# Corrigenda — CIBSE AM17

Page 43, Figure 32

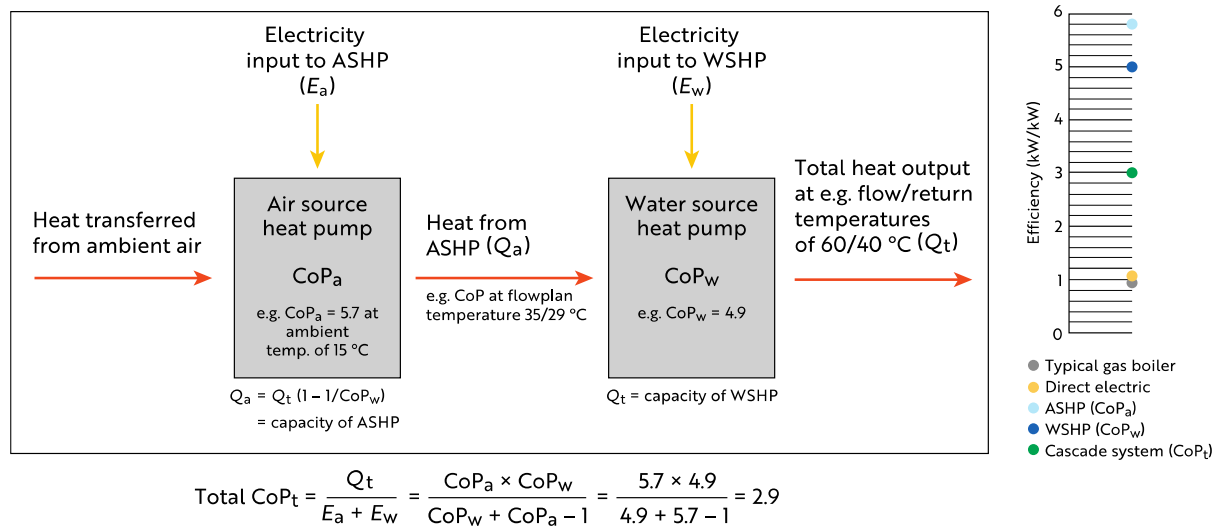
In left-hand grey box ('Air source heat pump'), CoP_s should read CoP_a (two occasions)

Text under right-hand grey box ('Water source heat pump'), Q_a should read Q_t

The corrected figure appears below.

$$\text{Total } CoP_t = \frac{Q_t}{E_a + E_w} = \frac{CoP_a \times CoP_w}{CoP_w + CoP_a - 1} = \frac{5.7 \times 4.9}{4.9 + 5.7 - 1} = 2.9$$
